TECHNICAL BULLETIN

Q278NAS1
09 OCT 2013

Service Action: Battery Box Water Ingress

Range Rover (LG)
Model Year: 2013
VIN: DA100499-DA111073

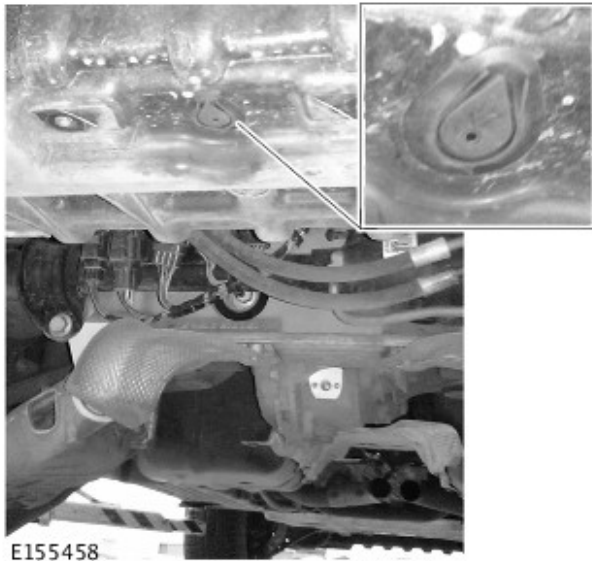
**4. Remove the blanking plug.**

- If required, allow water to drain completely.

5. Install the new one-way valve into the removed blanking plug hole.
